CALIFORNIA COASTAL COMMISSION

AMENDMENT REQUEST
STAFF REPORT AND PRELIMINARY RECOMMENDATION

Application No.: A-6-OCN-02-121-A-1/6-03-23-A1

Proposed Amendment: The addition of a vehicular gate at the roadway entrance into the project site. Gates to remain open from sunrise to 10 p.m. daily.

EXHIBIT NO. 4
APPLICATION NO.
6-03-023-A1
Residential Gate Site
Plan
California Coastal Commission

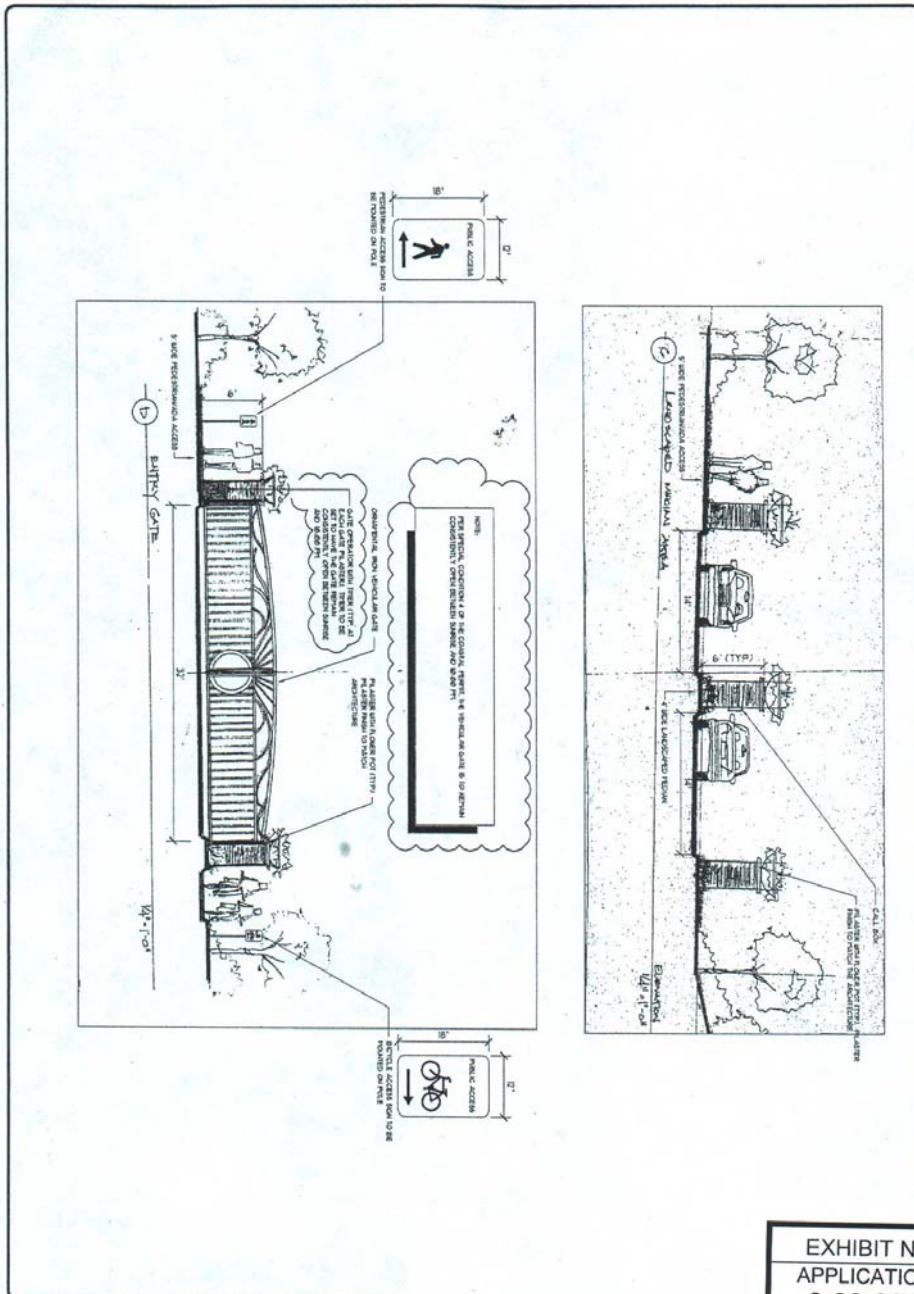
The proposed amendment is for the addition of a vehicular gate with a 30' radius turnaround at the road way entrance into the project (ref. Exhibit #4). The proposed gate would be located approximately 250' into the project roadway. As proposed there will be three 6' tall pilasters with decorative flower pots at the main entry. The center pilaster will have a call box for guests visiting residents. Just beyond the call box is the 30' radius turn around area. Beyond the turnaround area is the 32' foot long iron gate. There are two pilasters located at either edge of the gate; these will also hold decorative flower pots. It is alongside this gate that the additional public access signage is proposed. The gate would be operated by a timer that will be set to have the gate remain open between sunrise and 10 p.m. daily. Both the bike trail and the pedestrian access would remain accessible to the public by going around the proposed gate. The access signs would be approximately 18" x 12" and have a height just below 5' (ref. Exhibit #4). Additional access signs required by the original approval will remain, but will be located within the proposed gated area. The public access signage required by CDP #6-03-023, to be visible from Pacific Coast Highway, will remain. There is no public parking provided onsite.

The applicant has expressed that the gate is intended to be used to restrict the public from driving into the residential area at night after 10 p.m. thereby decreasing traffic activity and minimizing any potential safety concerns. However, no information documenting safety concerns and the need for the gate has been submitted. Again, the proposed entry gate will be approximately 32 ft. long and 6-ft. high and include imposing 6' high pilasters on either side. Although access to the bike path and pedestrian trail will remain available to the public around the proposed gate, the gate would convey a strong message that no access is allowed. There will be a perception by the addition of a gate, that no further public amenities remain.

The applicant has proposed to mitigate for the gate by installing the additional signage at the gate to inform the public of the availability of the pedestrian and bike paths. While the presence of signage that informs the public of the location of public access can help overcome the public access barriers created by private communities, they do not compensate for perception the gate will convey when observed by the public. As the public approaches the development they will observe the gate and interpret the area as private long before they come close enough to the gate to see the public access signage, therefore public access is not only not facilitated, it is actually discouraged. In addition, the applicant has also proposed to mitigate for the gate by keeping it open during daylight hours such that it would only be closed from 10:00 p.m. to sunrise each day. Thus the public could gain access through the site during the daytime, when it is most appropriate. Again, such mitigation is not sufficient for several reasons. First, while the gates may remain open during the day, the public will still see the gates as they approach the development and it is likely will have same perception as if the gates were closed – this is a gated community and the public is not welcome. Second, it would be impossible for the Commission to monitor operation of the gates to assure they remain open during daylight hours. Thus, it could not be assured the gates would always be open once installed.

Summary of Staff's Preliminary Recommendation: Staff is recommending denial of the proposed vehicular gate construction request. The proposed project would create a gated residential subdivision between the first public road and the sea and raises several issues with regard to coastal access and recreation. In 2003, the Commission approved the project with conditions including, among others, a requirement that public bicycle and pedestrian access be provided from Coast Highway, along the entrance drive and through the project to access the San Luis Rey River and the public bicycle path that runs along its shoreline. While the proposed vehicular gate will not directly block the public bicycle and pedestrian paths, the gate, even with signage, will create a perception that the public access facilities (pedestrian trail and contiguous bike path) are in fact private, leading to a decrease in public access. In addition, although the applicant has proposed to leave the gates open from sunrise to 10:00 p.m. daily, that raises an enforcement issue and it is not possible for Commission staff to monitor the gate operations on a daily basis. Thus, the proposed gate will deter the public from using the public access facilities, the facilities
